SEWAGE DISPOSAL TESTING

MARYLAND STATE DEPARTMENT OF HEALTH

HOWARD COUNTY

RE: Property on Nichols Road
off Brighton Dam Road

PLAT OF SURVEY
FOR
WOODROW JONES

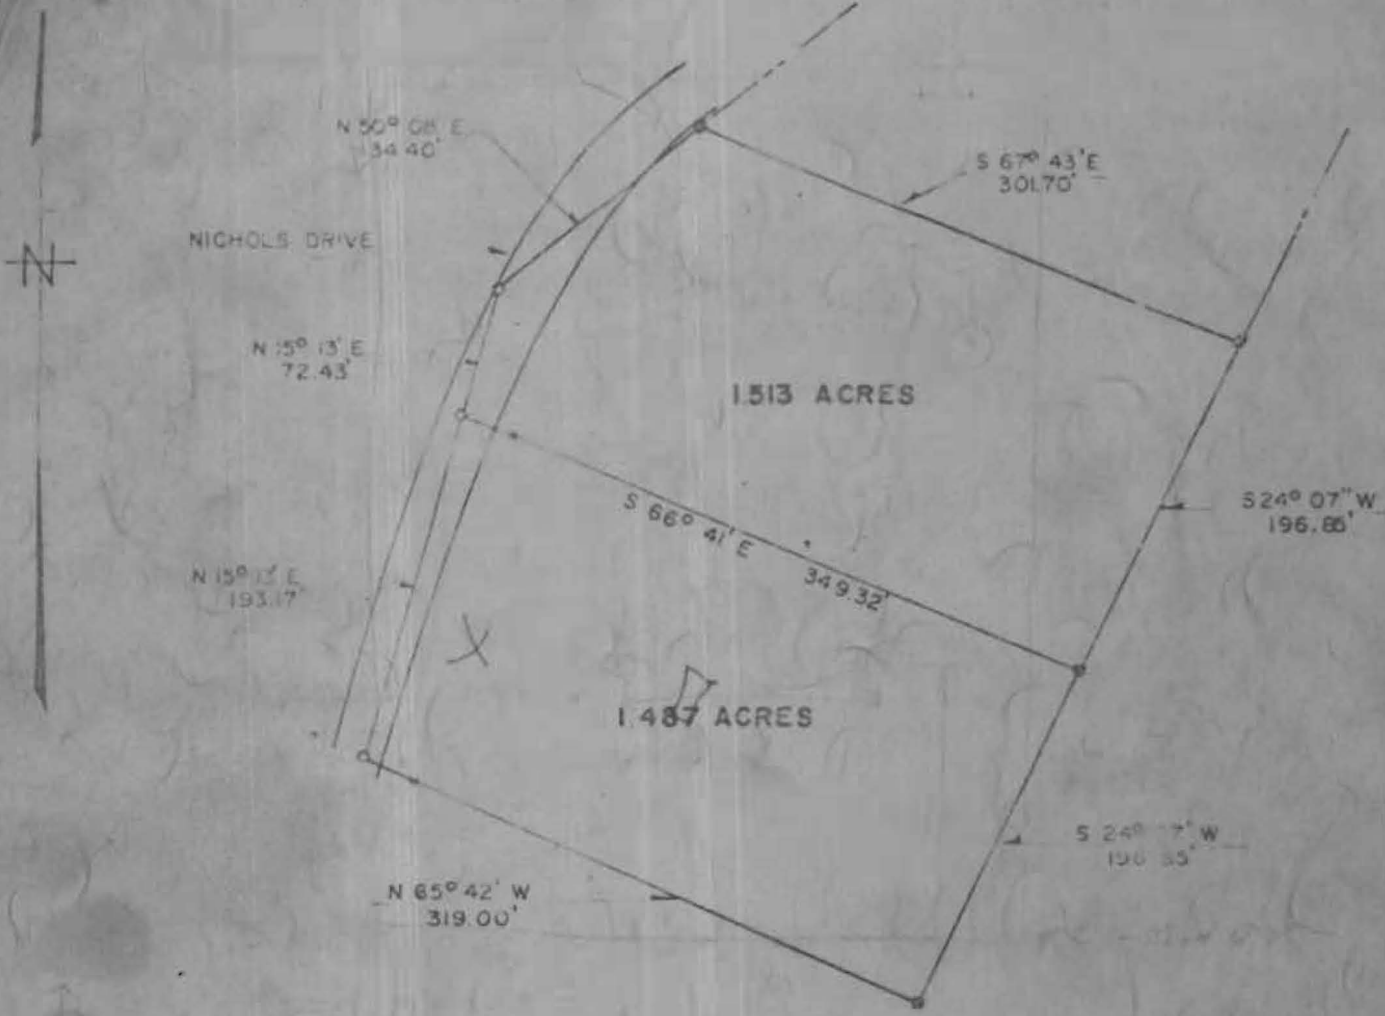
1 + 2 ⁱⁿ test 10 min. - 5 ft.

3rd hole 14 min. 1st inch
20 min. 2nd inch = 11 ft.

no water
